## Report to the Future Melbourne (Planning) Committee

### Ministerial Planning Referral: TPM-2020-63 2-50 Elizabeth Street, Kensington (Younghusband Stage 2)

7 September 2021

## DELEGATE REPORT

Excerpt from 'Elevation East - Elizabeth Street', Drawing No. SK 2 3300, Revision B

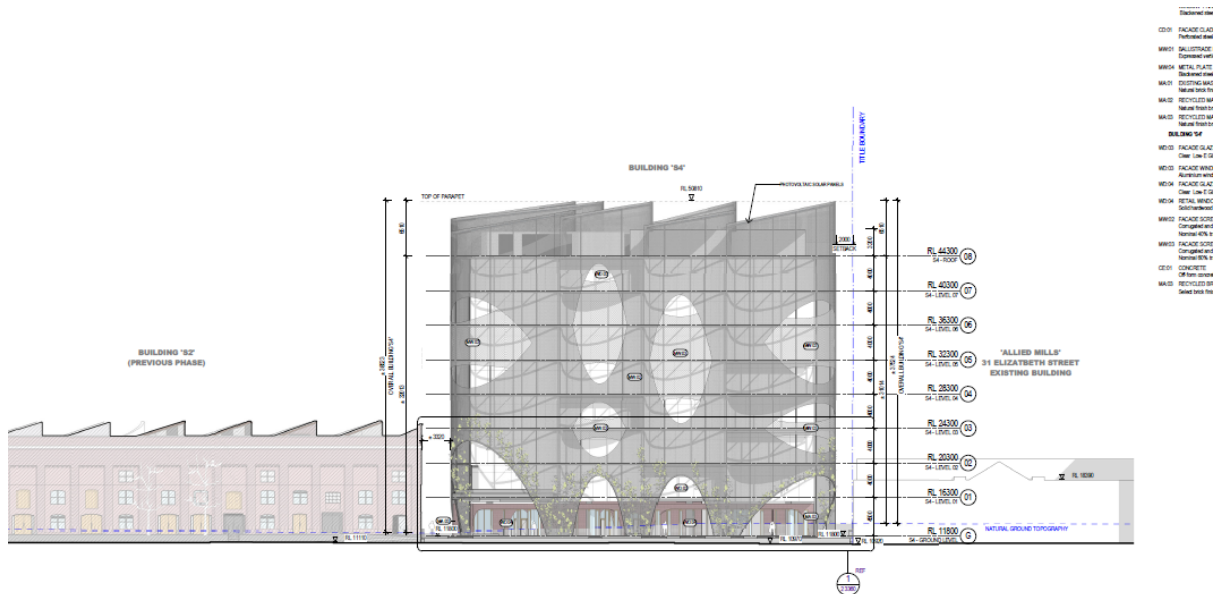
*The prominence of this element when viewed from Elizabeth Street to the south could be reduced by the removal of the southernmost bay as shown on the second enclosed perspective and on the enclosed amended Elizabeth Street elevation (Drawing SK 2 3300 Revision C) and Level 05 floor plan (Drawing SK 2 2305 Revision C).*

- e) Revisions to the height of proposed windows at Level 01 of the addition to the Tallow Store (window head to be at least one brick course below the existing “YOUNGHUSBAND LIMITED TALLOW STORE” sign), generally in accordance with the discussion plans received on 9 July 2021, including the Elizabeth Street Elevation (Drawing SK 2 3300 Revision C).

- a) Removal of the southernmost bay of Level 04 to reduce the visual prominence of this addition when viewed above the Tallow Store from Elizabeth Street, generally in accordance with the discussion plans received on 9 July 2021, including the Elizabeth Street Elevation (Drawing SK 2 3300, Revision C) and Level 05 Floor Plan (Drawing SK 2 2305, Revision C).

**Diagram 1: Level of visibility of additions to Tallow Store and Building 'S4' at saw-tooth nadir, Excerpt from plan: 'Section – East to West 02', Drawing No. SK 2 3351, Revision B**

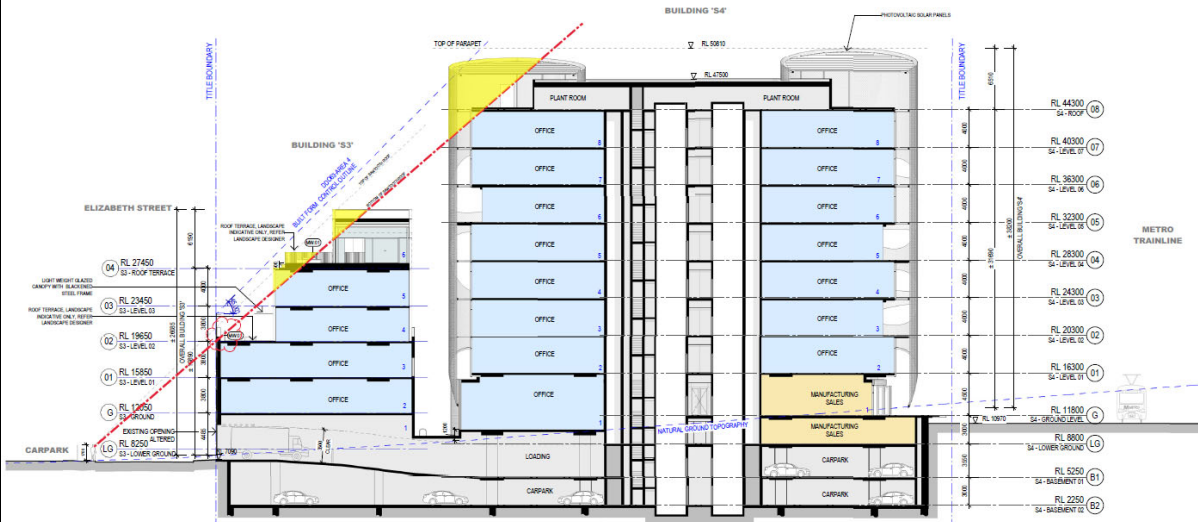
visibility of the additions to the Tallow Store and Building 'S4' is variable. This variability is captured in the diagrams provided below (with visible elements highlighted yellow).

Subject to a condition being included on any permit being granted providing a detail (1:50) scale section, which highlights the relationship between the expressed vertical balustrading and saw-tooth parapet (including the distance between these elements, which must be sufficient to conceal the balustrade from view at street level), it is considered that an appropriate level of concealment is achieved from this viewing angle.

**Excerpt from plans: Overall Concept Plan (p.17 of Landscape Report)**

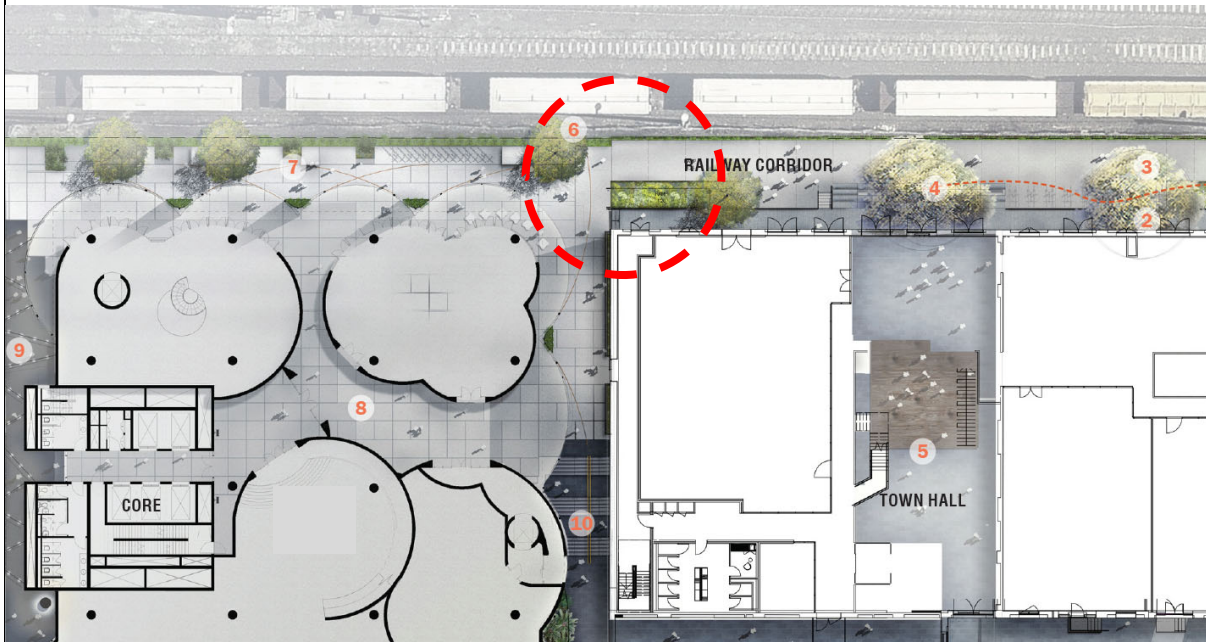
As identified in the advice of Council’s Urban Design team, the design vision for the segment of the thoroughfare adjacent to the railway reserve falling within Stage 2 of the Younghusband redevelopment project is not considered to adequately integrate or provide high quality connectivity with the design vision of the movement corridor within the scope of Stage 1.

The connection between Stage 1 and Stage 2 of the railway thoroughfare currently presents as disjointed, due to what appears to be a level change, inconsistency in landscaping/paving and other feature differences at the border that would obstruct clear, straight, sightlines through this link to the southern boundary with Allied Mills.

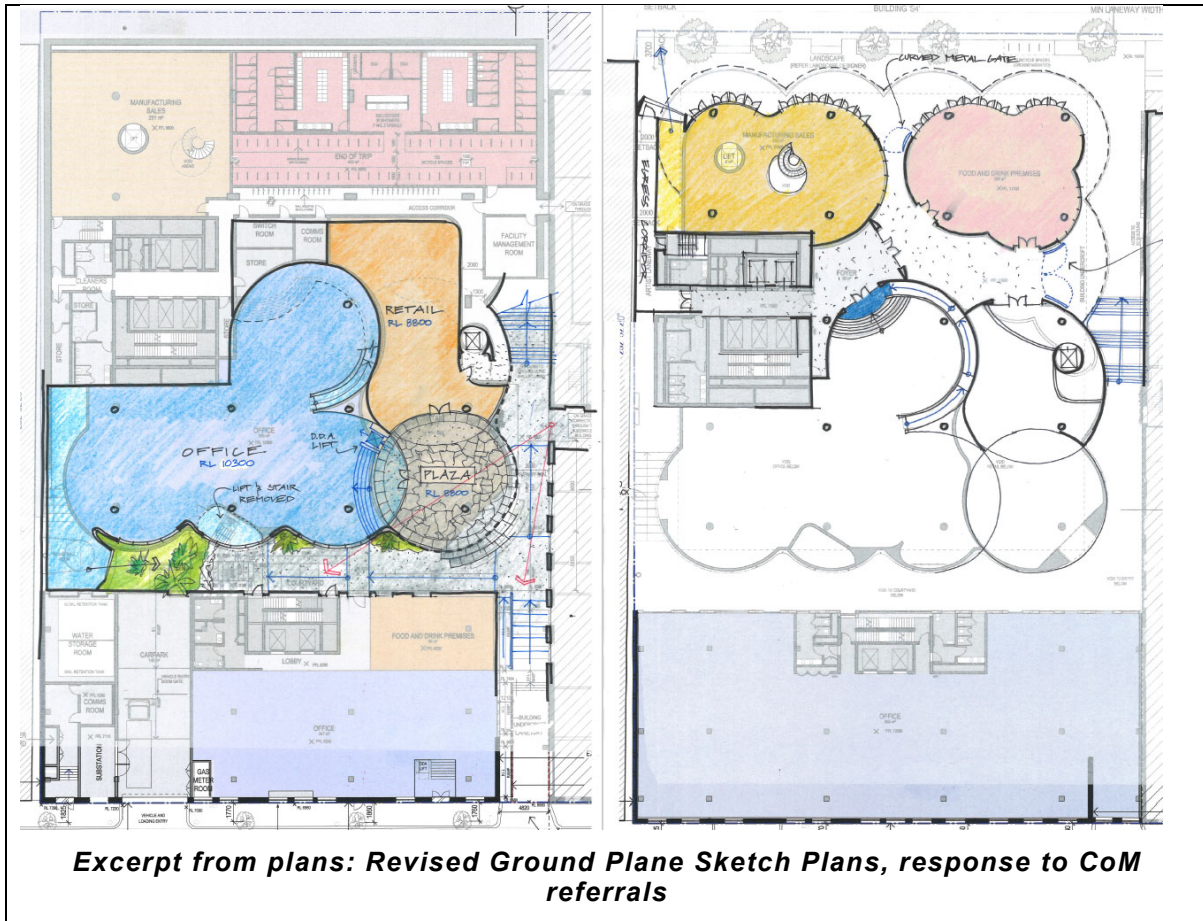
Further refinement of the layout of the internal pedestrian network has been suggested by Council's Urban Design team, and the applicant has prepared additional discussion plans to address concerns relating to the quality and width of the internal connections, in addition to the safety of these areas after-hours.

The sketch plans prepared by the applicant (excerpt below) indicate a series of curved metal gates to manage after-hours access along the rear ground floor level interface and the removal of the 'artist laneway' along the southern boundary. These design changes are considered to effectively manage safety concerns while rationalising the network of internal pedestrian connections.

- *The sketch plans indicate a series of curved metal gates to manage after-hours access along the rear GFL interface and the removal of the 'artist laneway' along the southern boundary. These measures effectively manage safety concerns while rationalising the network of internal pedestrian connections.*
